App. Serial No. 10/539,383  
Docket No.: NL021429

**Remarks**

Serial No. 10/539,383  
ANNOTATED SHEET

FIG. 2

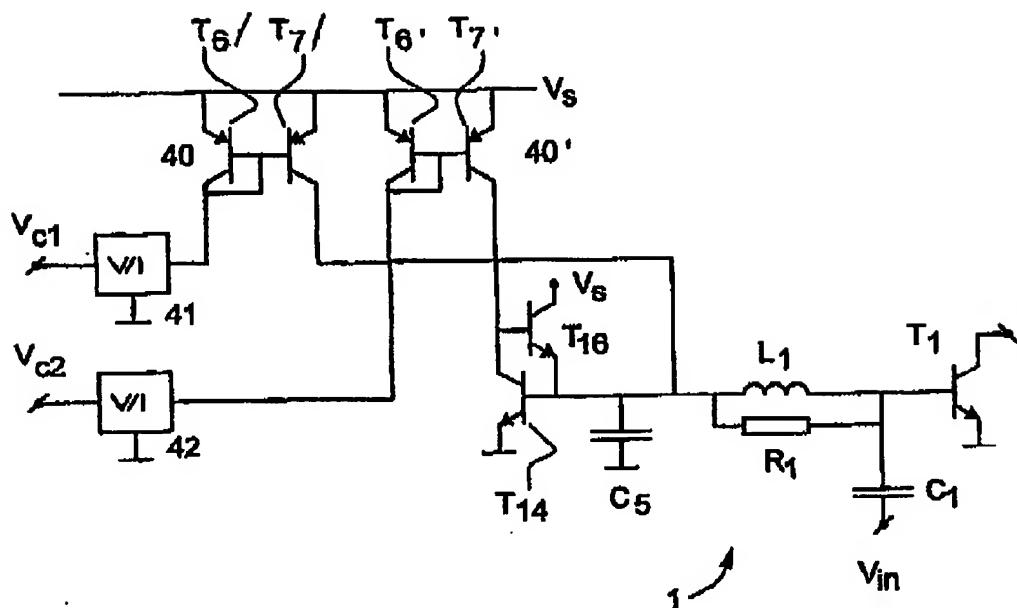
Please find attached one Replacement Drawing Sheet for entry, Figures 2 and 3. The only change from the immediate version is in Figure 2 where the labels for current mirror 40 have been changed from T6' and T7' to T6 and T7 respectively. No other changes to the Figure 2 have been made.

Regarding the objections to the drawings, Applicant has amended the Specification as indicated on page 2 of this paper to provide a specific reference to inductors L<sub>5</sub> and L<sub>6</sub>. Applicant notes that paragraph 0033 states that the third stage is substantially identical to the second stage 2, which is discussed in detail in paragraph 0032 including discussion of inductors L<sub>3</sub> and L<sub>4</sub> which correspond to inductors L<sub>5</sub> and L<sub>6</sub>. As such, no new matter has been added by this amendment. Applicant has also provided a replacement drawing sheet as indicated on page 3 of this response in which Figure 2 has been amended to change the labels for the transistors of current mirror 40 from T6' and T7' to T6 and T7 respectively. Accordingly, Applicant submits that the objections to the drawings have been overcome and Applicant requests that they be removed.

Paragraphs 0036-0038. More specifically, Prikhodko's transistors 36 and 38 and current mirror (transistors 32, 34) provide a bias voltage to the base of transistor 2, as is further demonstrated by an identical arrangement in Applicant's Figure 2 consisting of current mirror 40' (transistors T6', T7') and transistors T<sub>14</sub> and T<sub>15</sub>, which provide a bias voltage instead of a bias current. See, e.g., Paragraph 0035 of Applicant's Specification. Thus, the cited portions of Prikhodko do not teach supplying a bias current to the control electrode of the signal amplification transistor as in the claimed invention. Accordingly, the Section 102(c) rejection of claims 1-3, 5, and 7-9 is improper and Applicant requests that it be withdrawn.
